# Access Compliance Report

## Public Rights-of-Way

### (Curb Ramps)

Intersection ID: N/A	Main Street: SHARON_AMITY_RD	Cross Street: INDEPENDENCE_RD	Location: SE
ADA ID: 2042CA1D6651	Ramp Type: Perp	Initial Pass/Fail: Fail	Overall Compliance: No
Severity Score: 12.5			
Codes/Mitigation Info/Possible Solution		Field Measurements/Component Compliance

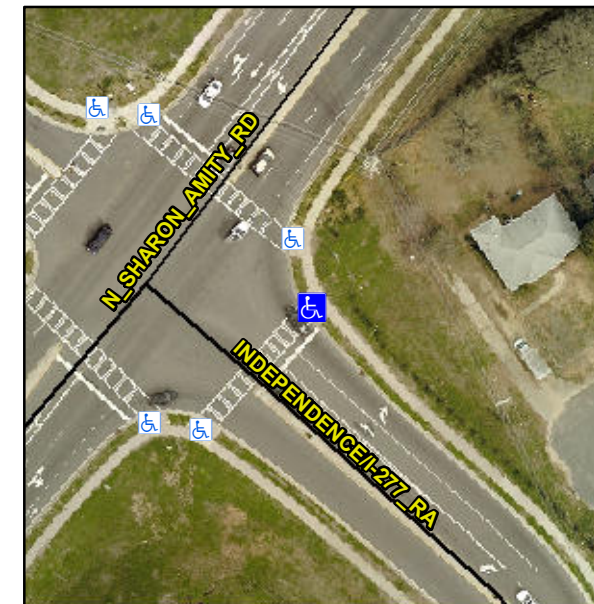
Compliance	Description	Data	Compliance	Description	Data
N/A	Ramp Length (in)	63.0	No	Ramp Slope (%)	8.6
Yes	Ramp Width (in)	59.0	Yes	Ramp XSlope (%)	0.1
N/A	Flare Type LT	N/A	N/A	Flare Type RT	N/A
N/A	Flare Slope LT (%)	N/A	N/A	Flare Slope RT (%)	N/A
N/A	Flare Traversable LT?	N/A	N/A	Flare Traversable RT?	N/A
N/A	Landing Length (in)	N/A	N/A	DWS Provided?	N/A
N/A	Landing Width (in)	N/A	N/A	DWS Contrast?	N/A
N/A	Landing Slope (%)	N/A	N/A	DWS Length (in)	N/A
N/A	Landing X Slope (%)	N/A	N/A	DWS Full Width?	N/A
N/A	Landing Curb? (Y/N)	N/A	N/A	DWS Offset (in)	N/A
N/A	Shared Landing?	N/A			
N/A	Gutter Ponding?	N/A	N/A	Gutter Slope (%)	N/A
N/A	Gutter Lip Ht (in)	N/A	N/A	Gutter X Slope (%)	N/A
N/A	Painted X Walk1?	Yes	N/A	Painted X Walk2?	N/A
	X Walk 1 Direction	To SW		X Walk 2 Direction	N/A
N/A	X Walk 1 Width (in)	111.0	N/A	X Walk 2 Width (in)	N/A
	X Walk 1 Slope (%)	6.0		X Walk 2 Slope (%)	N/A
	X Walk 1 X Slope (%)	4.0		X Walk 2 X Slope (%)	N/A

**Remove & Replace Entire Ramp.**
